GEORGIA POWER COMPANY
OGLETHORPE POWER CORPORATION
MUNICIPAL ELECTRIC AUTHORITY OF GEORGIA
CITY OF DALTON, GEORGIA
DOCKET NO. 50-321
EDWIN I. HATCH NUCLEAR PLANT, UNIT NO. 1
AMENDMENT TO FACILITY OPERATING LICENSE

Amendment No. 101
License No. DPR-57

GEORGIA POWER COMPANY
OGLETHORPE POWER CORPORATION
MUNICIPAL ELECTRIC AUTHORITY OF GEORGIA
CITY OF DALTON, GEORGIA
DOCKET NO. 50-366
EDWIN I. HATCH NUCLEAR PLANT, UNIT NO. 2
AMENDMENT TO FACILITY OPERATING LICENSE

EDWIN I. HATCH NUCLEAR PLANT, UNITS NOS. 1 AND 2
DOCKETS NOS. 50-321 AND 50-366

FIGURE 2.1-1

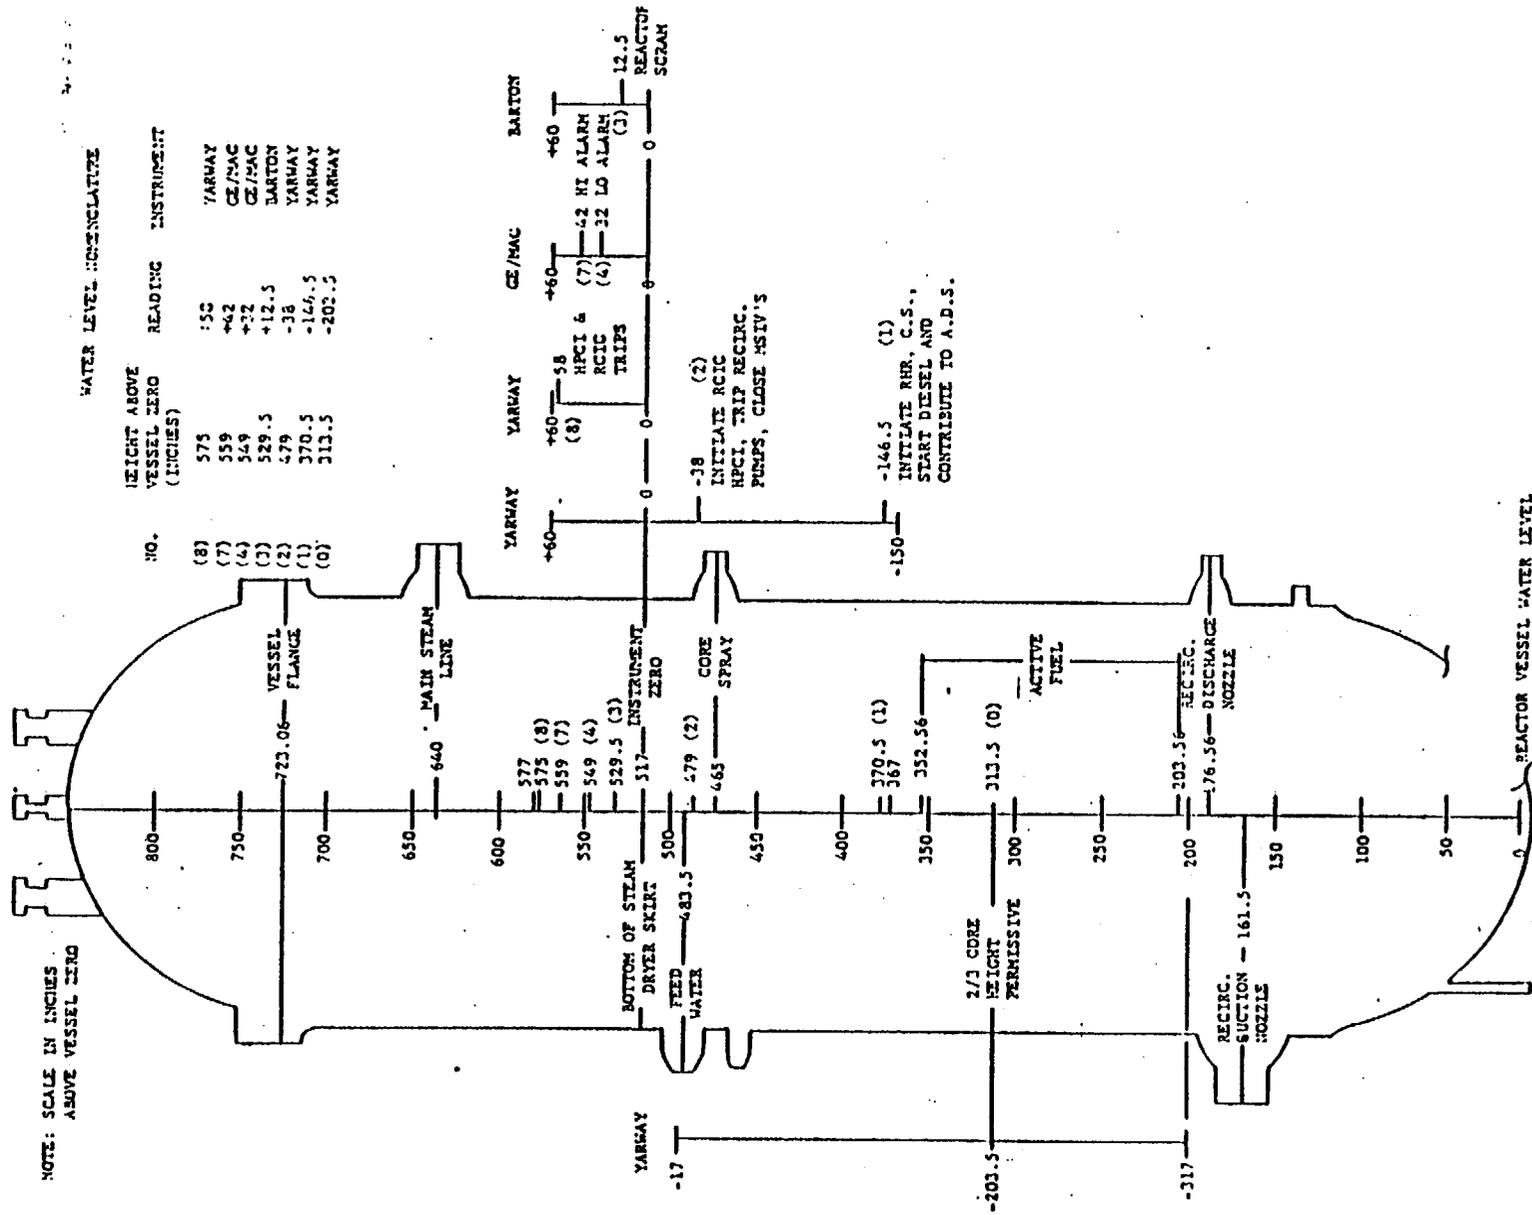
The amendments revise the TSs for Hatch Unit 1 to: reflect common reactor vessel water levels established in response to NUREG-0737, Item II.K.3.27 and for Hatch Unit 2 to reflect the modifications to pipe break detection circuitry made in response to NUREG-0737, Item II.K.3.15.

The guidance provided in Generic Letter 83-02 recommended that the figure defining reactor vessel water levels should be changed to reflect the common reference level established by this Action Plan Item. A sample figure was provided in the guidance.

In response to Generic Letter 83-02, the licensee submitted a proposed change in Figure 2.1-1 for Hatch Unit 1. This figure for Hatch Unit 2 was revised by a previous amendment.

We have reviewed the revised figure which defines reactor vessel water levels. We find that it reflects the common reference level established by the Action Plan Item II.K.3.27. We find the proposed change to be acceptable.
